SHOP DRAWING

A.D.A. LABORATORY WORKSTATION

SUBMITTAL IDENTIFICATION SHEET

WEBSTER UNIVERSITY ISB	
PROJECT NAME	
8274 BIG BEND BLVD	
ADDRESS	
NUMBER	
WEBSTER UNIVERSITY	
OWNER	
CANNON DESIGN	
ARCHITECT / ENGINEER	
DEVIN D GATES	
SUBMITTED BY	
123553-001 REV 2	
CONTRACTOR / CM SUBMITTAL NO.	CANNON DESIGN SUBMITTAL NO.
	123553
DRAWING / DETAIL REFERENCE	SPECIFICATION SECTION / PARAGRAPH
MANUFACTURER / SUPPLIER	ITEM / PRODUCT ID
REQUIRED DATE	PRIORITY
	CRITICAL

SHEET
1 OF 3

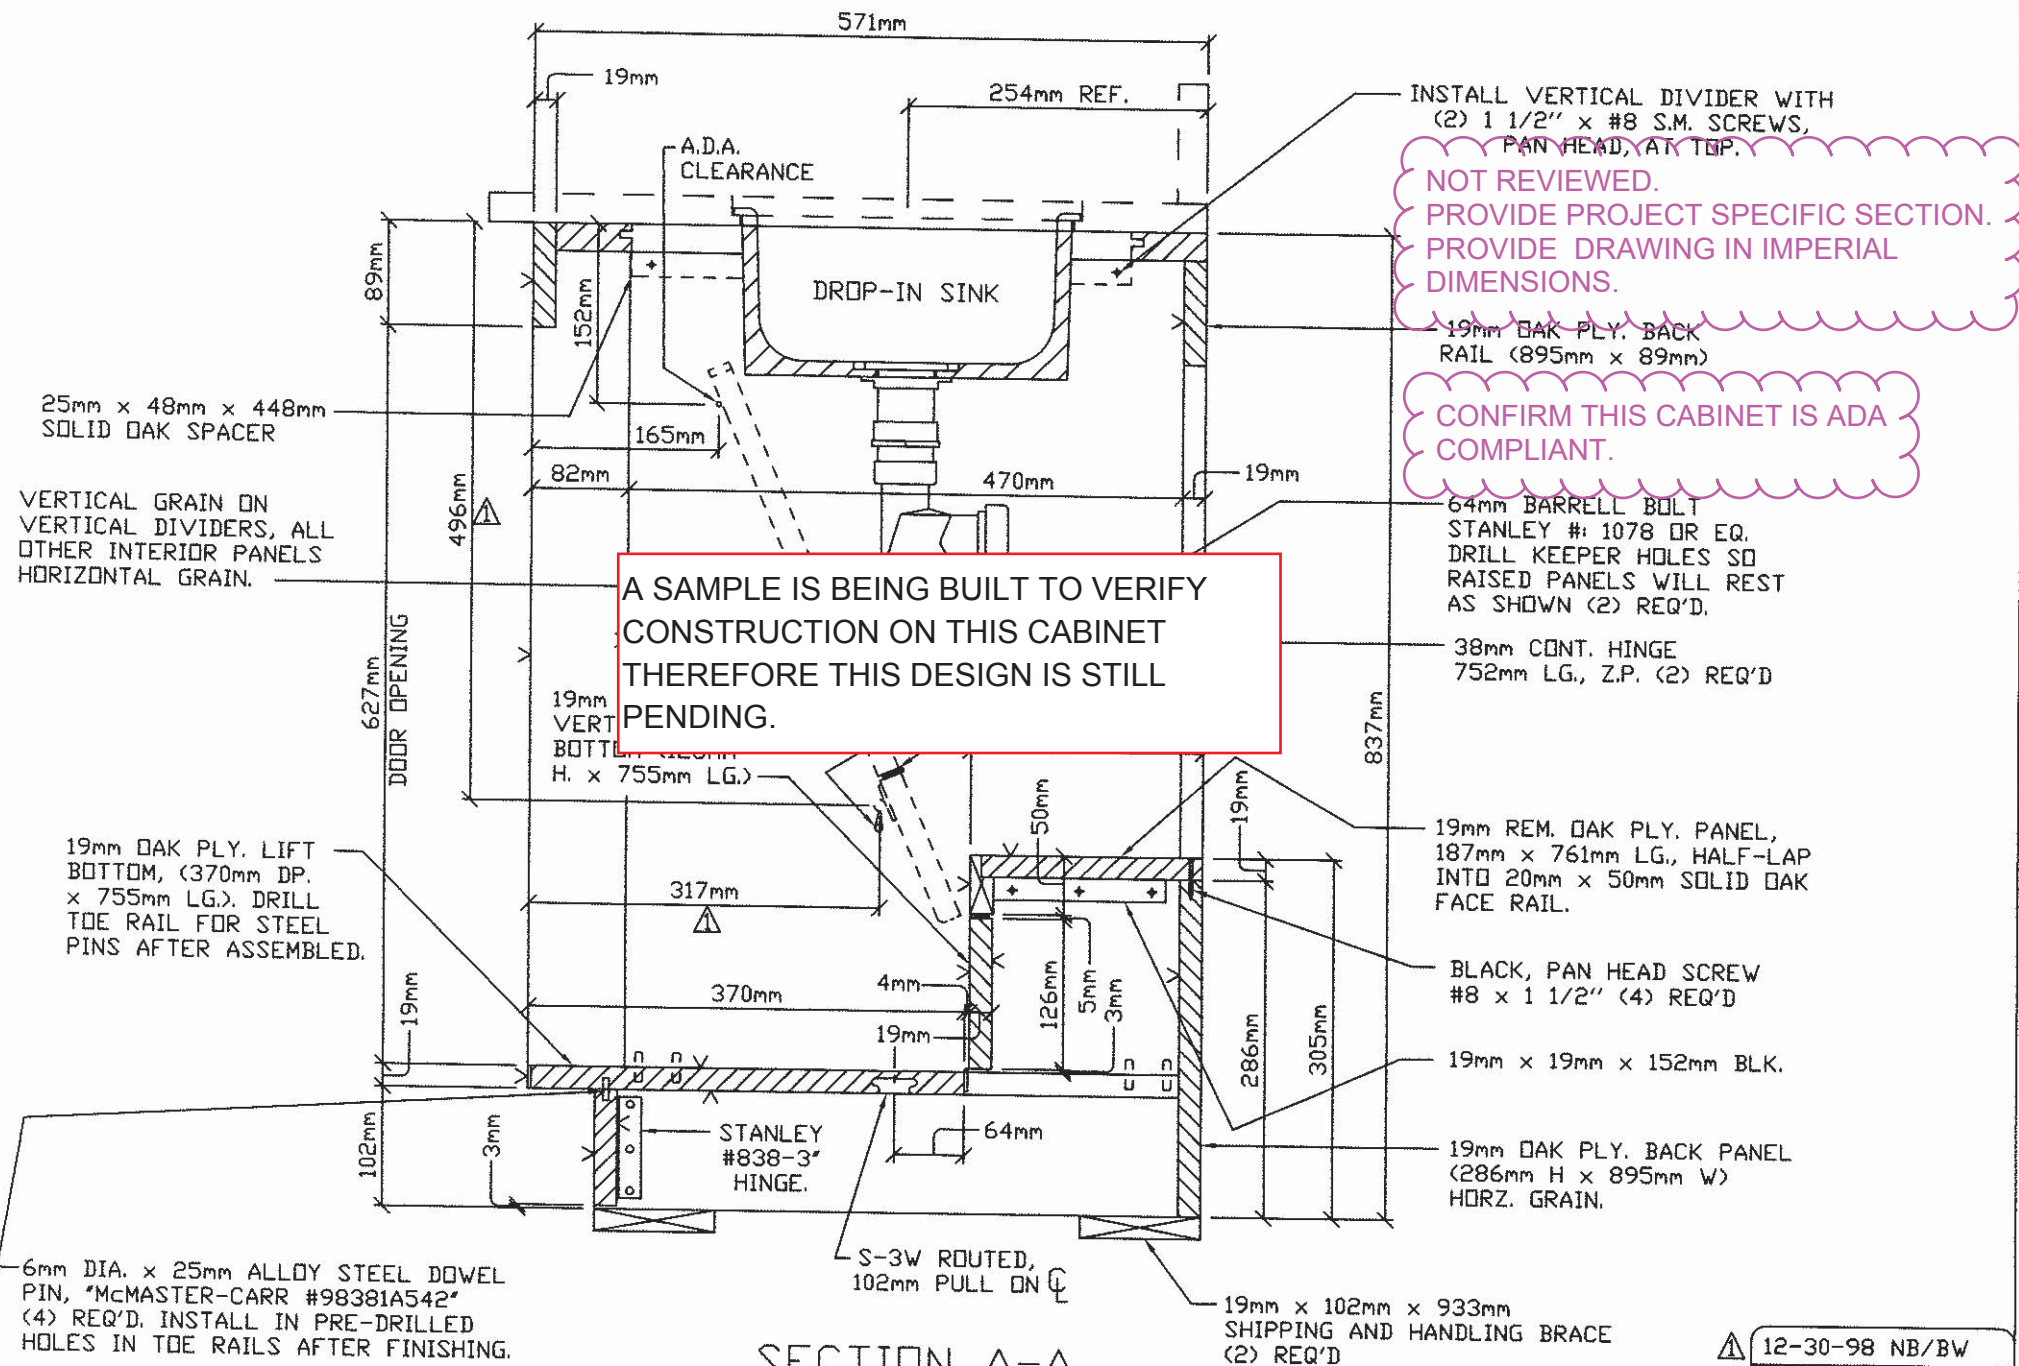
CONFIRM THIS CABINET IS ADA COMPLIANT.

NOT REVIEWED.
PROVIDE PROJECT SPECIFIC SECTION.
PROVIDE DRAWING IN IMPERIAL
DIMENSIONS.

A SAMPLE IS BEING BUILT TO VERIFY
CONSTRUCTION ON THIS CABINET
THEREFORE THIS DESIGN IS STILL
PENDING.
